TECHNICAL MEMORANDUM

SUBJECT: Recommended Scope of Services and Budget of the Ground-Level Monitoring Committee for Fiscal Year 2021/22 (Final)

Response to GLMC Comments

Figure 6-11 “Mean Residual Error of Calibration Wells” from the 2020 Safe Yield Recalculation is reproduced below. The Northwest MZ-1 area shows a high mean residual error relative to other parts of the basin.

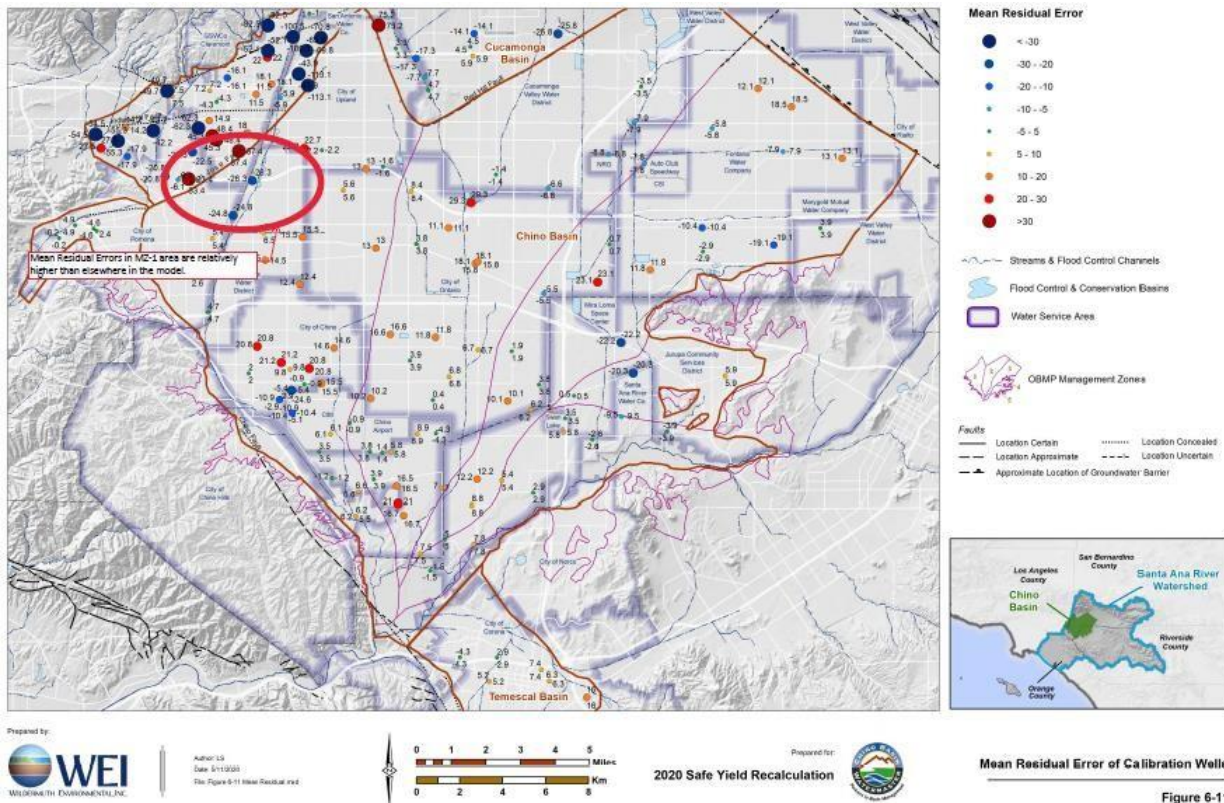
Comment 10 – Groundwater Elevation

The PX facility and the planned extended pumping test will provide layer specific groundwater elevation data. Additional calibration efforts or updates to the conceptual model may be required if predicted water levels in the deep PX completions are not consistent with MODFLOW model predicted water level and model predicted changes in water level.

The TM should provide data on the sensitivity of estimated pre-consolidation stress and other model based subsidence estimates to variation in layer specific model-simulated heads.

The head data that is being collected at the PX piezometers will be valuable data for the future recalibrations of the CVM and the 1D model. However, we advise that those recalibration efforts and expenses are best planned for 5-10 years from now, when the data set is long enough to justify the recalibrations.

Sensitivity analyses for the 1D compaction models should be discussed by the GLMC and added to the scope of work if agreed upon by the GLMC.

The Model-Simulated deformation vs InSAR-Estimated ground motion figure is reproduced
Model-Simulated Aquifer-System Deformation versus InSAR-Estimated Ground Motion at the
Pomona Extensometer Facility for the Final Calibrated 1D Model

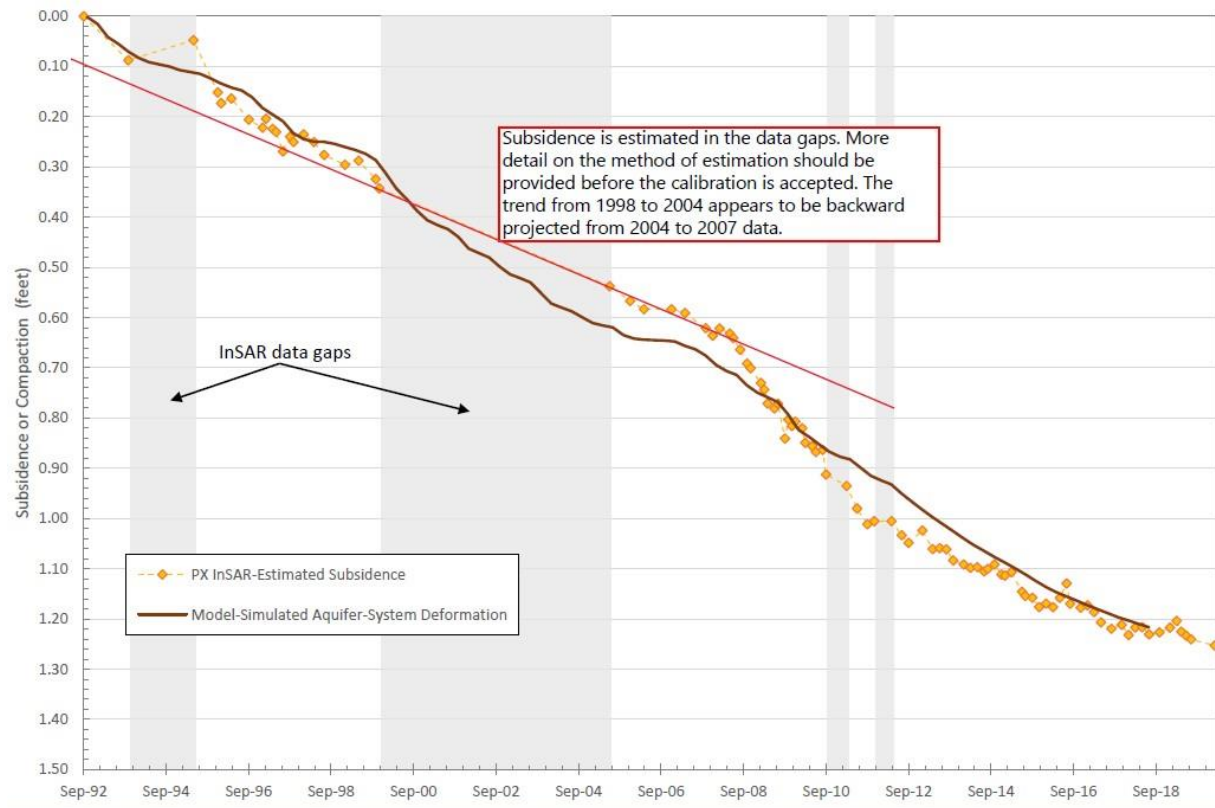
Comment 11 – InSAR-Estimated subsidence and Model-Simulated Aquifer System Deformation

During the March 4 meeting, WY presented InSAR-Estimated subsidence and Model-Simulated Aquifer System Deformation for the PX 1D model. InSAR data gaps were shown, with the InSAR-Estimated Subsidence projected through the data gaps. WY did not provide the method used to estimate subsidence

in the data gap. Additional detail on the method should be provided before the calibration is accepted. The prediction trend appears to be backward projected from September 2004 to late 2007 levels.

If possible, the InSAR data should be compared to land level survey data. GLMC was not conducting ground level surveys in Northwest MZ-1 throughout the 1992 through 2018 period. However, there are Los Angeles County Department of Public Works Survey Division (LADPW) leveling circuits near the PX facility, with the closest benchmark approximately 700 ft away. The LADPW surveys are not conducted to the same accuracy as the GLMC leveling surveys, but the historical data may provide an additional check to InSAR estimated subsidence.

The GSSI comments and questions are not related to the recommended scope of work, but are intended for consideration in constructing, calibrating, and documenting the 1D compaction models at the MVWD-28 and PX locations. The comments are noted.

The *Task 3 and Task 4 of the Work Plan to Develop a Subsidence Management Plan for the Northwest MZ-1 Area: Development and Evaluation of Baseline and Initial Subsidence – Management Alternatives*, describes the effort by WSP USA (former surveyor for the GLMP) to validate the InSAR-derived estimates of vertical ground motion in Northwest MZ-1 using historical ground-elevation data from repeated leveling surveys performed by the National Geodetic Survey (NGS) and the Metropolitan Water District of Southern California (MWD). At the time of the investigation, the NGS and MWD survey data were the most accurate and best available historical estimates of vertical ground motion in Northwest MZ-1. These estimates were also used to check the reasonableness of the 1D compaction model at MVWD-28, which utilized the InSAR-derived estimates of vertical ground motion at one specific location as calibration targets.

The use of the LADPW survey data referenced by Geoscience should be discussed by the GLMC and added to the scope of work if agreed upon by the GLMC.
